13 September 2023

Tennessee Council of Trout Unlimited Comments on Center Hill Dam Water Control Manual Revision Environmental Assessment and Finding of No Significant Impact

Comments on Draft Environmental Assessment, 1998 Water Control Manual Revision, Center Hill Dam and Reservoir (dated 31 July 2023) and associated Draft Finding of No Significant Impact

Figure 1. Caney Fork River Cumulative Hours Below DO = 6.0 mg/L (Resource Manager side)
 Ref: Spaulding, Justin, unpublished data, Tennessee Wildlife Resources Agency (2023)

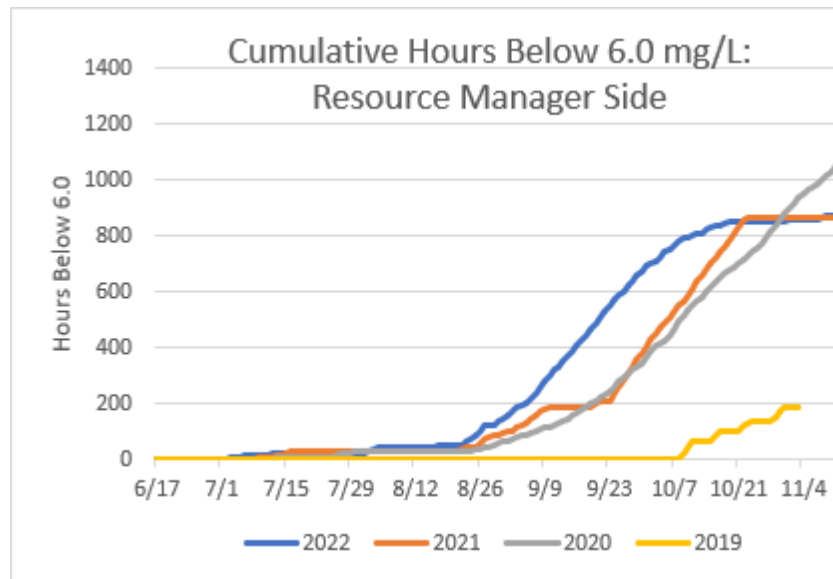
TCTU-02: USACE's recommended Alternative 4 will assure Center Hill Dam operations continue to inflict cumulating damage on the Caney Fork River ecosystem. Oxygen is essential to aerobic microbes, aquatic plants, fish and animals. The necessity of maintaining dissolved oxygen (DO) concentrations at or above 6.0 mg/L is well established for coldwater ecosystems and habitats. The EA states Alternative 4 *"is consistent with the operational conditions since 2021"*. (EA, p. i) Figures 1 and 2 and Table 1 and 2 below, depict and summarize Caney Fork River dissolved oxygen (DO) data collected during the same 53-day period in 2019, 2020, 2021, and 2022. The data was collected with instruments supplied by Trout Unlimited and monitored/analyzed by The Tennessee Wildlife Resources Agency (TWRA). The 2021-2022 data clearly demonstrate the inability of Alternative 4 and aerated turbines alone, to meet minimum acceptable DO concentrations in the Caney Fork River from late August to late October of each year. Additionally, the EA (p. 32-33) states when referring to the current water control procedures know as Alternative 4 in the EA, *"Within a 48-hour window, an 8-hour pulse shows flows in the 200-750 cfs range 6.3 percent of the time just below the dam and 37.5 percent at Lancaster Hwy. By the time the pulse gets to Happy Hollow, the period that flows are in the ideal range increases to 62.5 percent."* Eighty percent of the recreational use of the river occurs in the first five miles below the dam (i.e., in the section above Happy Hollow boat ramp).

TCTU requests the USACE re-issue a modified EA (or EIS) for public review and comment – an EA that openly acknowledges and appropriately weights the observed unacceptable impacts of Alternative 4 on Caney Fork River water quality.

Figure 3. Center Hill Dam Annual Electricity Generation 1998-2022
(Source Data: USACE)

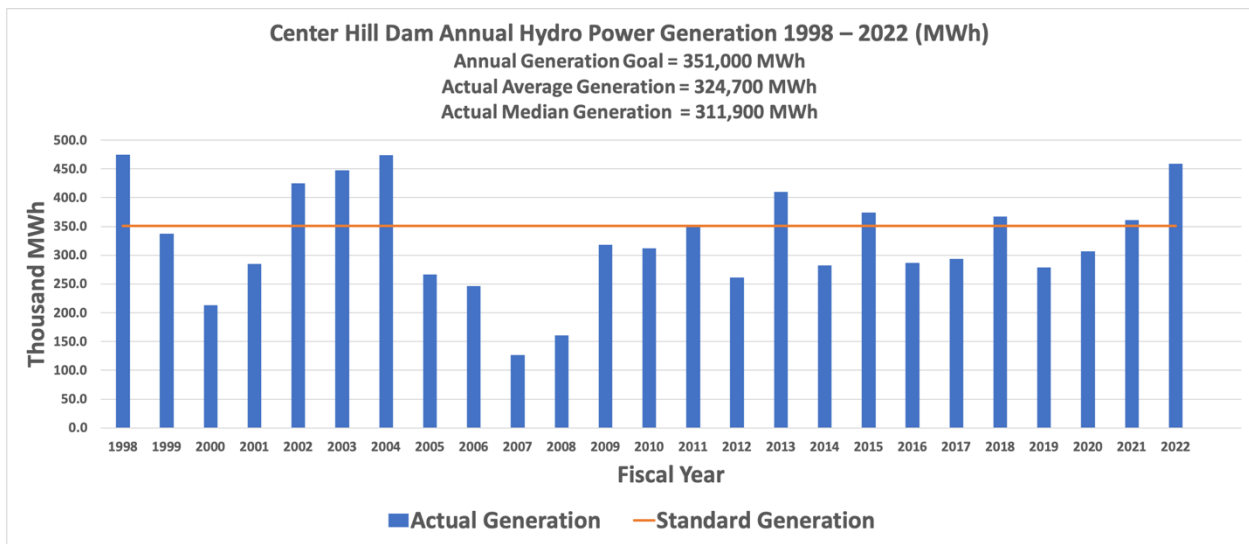
TCTU-11: USACE’s insistence that an Alternative meet the 351,000 MWh energy production metric is illogical and unjustifiable given Center Hill Dam has only achieved this hydropower production quota 9 times over the past 25 years. The USACE obviously does not and has not historically been able to enforce this criterion. Figure 3 depicts Center Hill Dam’s actual annual energy generation from 1998 through 2022 (25 years). During this most recent twenty-five year period, Center Hill Dam has only achieved USACE’s 351,000 MWh generation quota nine times (36% of the time). Indeed, the dam’s *average* annual generation during this period was only 324,700 MWh. Its *median* (meaning half of the time its generation was below this level and half of the time it was above this level) annual generation during this 25-year period was only 311,900 MWh. Thus, USACE’s own Center Hill Dam generating history data is proof positive the USACE DOES NOT AND CANNOT actually prioritize an annual energy production of 351,000 MWh in Center Hill Dam. The superposition of this unrealistic energy production criterion over all other evaluation criteria subjugates attainment of essential environmental and economic objectives to the pursuit of an objective that history demonstrates is only attainable ~ 36% of the time.

TCTU requests the USACE re-issue a modified EA (or EIS) for public review and comment – an EA that includes a justification for USACE’s insistence that Alternatives meet a 351,000 MWh/year hydropower production quota that Center Hill Dam has failed to meet two-thirds of the time over the past twenty-five years.
